**ON-SITE SEWAGE DISPOSAL SYSTEM
 HOWARD COUNTY HEALTH DEPARTMENT
 BUREAU OF ENVIRONMENTAL HEALTH**

HOUSE LOCATION DRAWING

MEMORANDUM

RE: 4340 Buckskin Wood Rive
Buckskin Ridge Lot 43
Proposed Grading within the Sewage Disposal Area

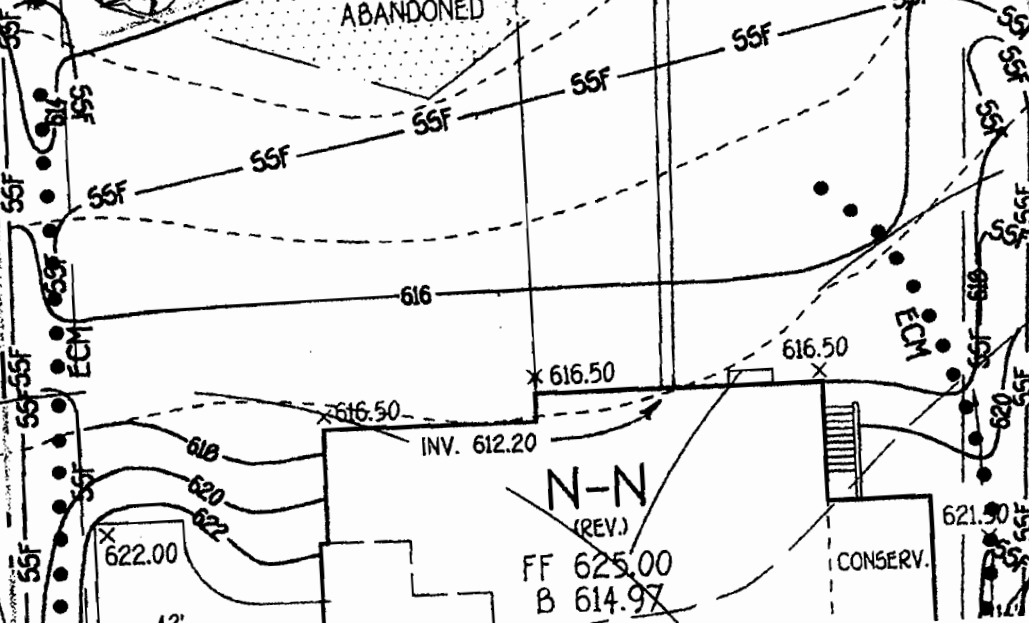
Attached is the site plan for lot #43, Bucksbin Ridge. The area that I spoke of is to start at the * marked on the top corner of the septic field area. It would go back about 40 feet, I would be wanting to add about 2-3 feet of dirt on that area and then re-grade it. Please call me on (410) 960-2504 to discuss after your review.

NEW PERC AREA
REQUIRED

AREA TO
BE ADDED

AREA TO
BE
ABANDONED

- Due to proposed grading within the septic area additional percolation tests may be necessary in order to confirm suitable soil conditions at the time of a future system upgrade or repair.
- The proposed swale shown along the northern property boundary must stay 25' from the septic area. The septic area may be revised without an additional percolation test in order to accommodate this setback. A Revised Percolation Certification must still be submitted for approval.
